SUNDRY NOTICES AND REPORTS ON WELLS

2. NAME OF OPERATOR
Merrion Oil & Gas Corporation

Canyon Largo Unit

305

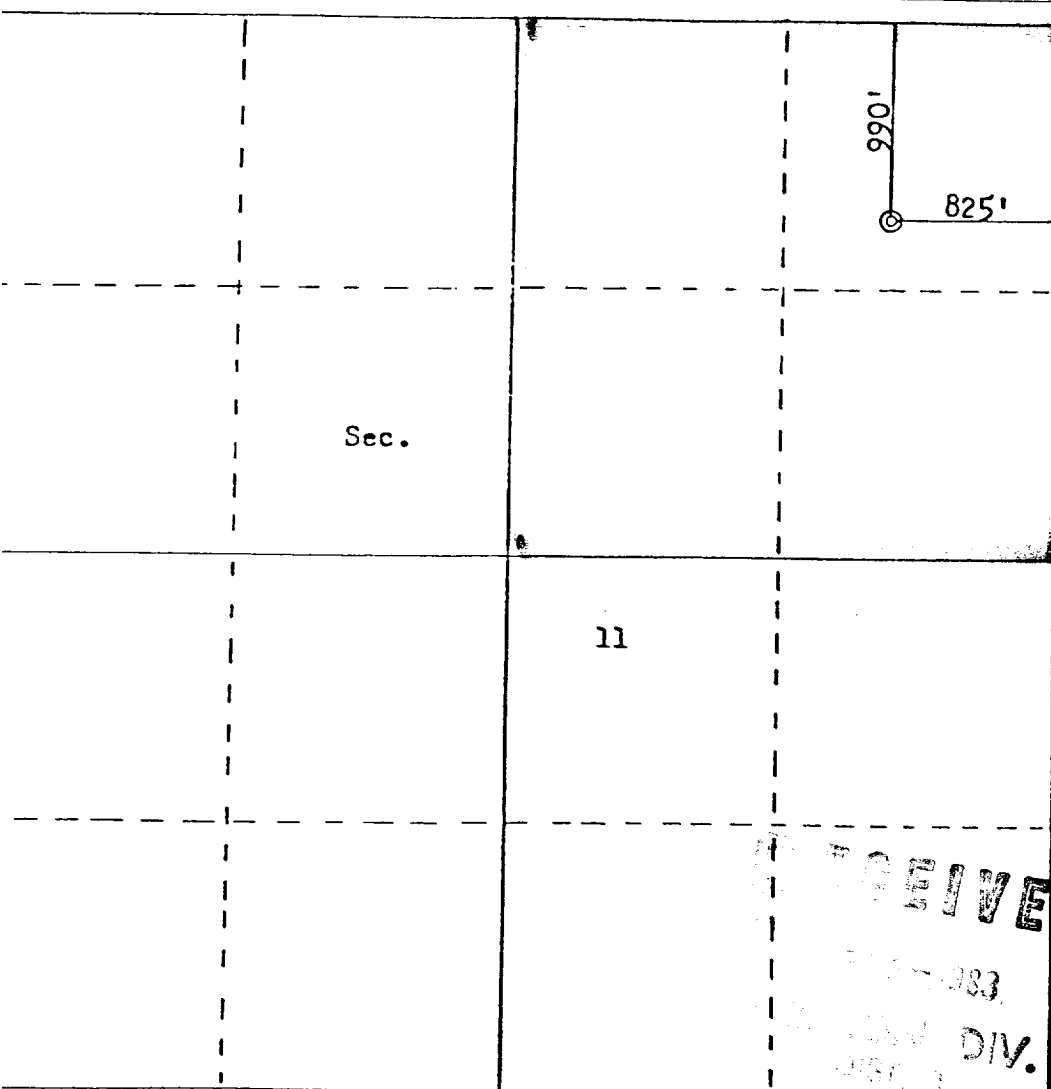
Attached is a plat indicating 160 dedicated acres instead of 80 dedicated acres.
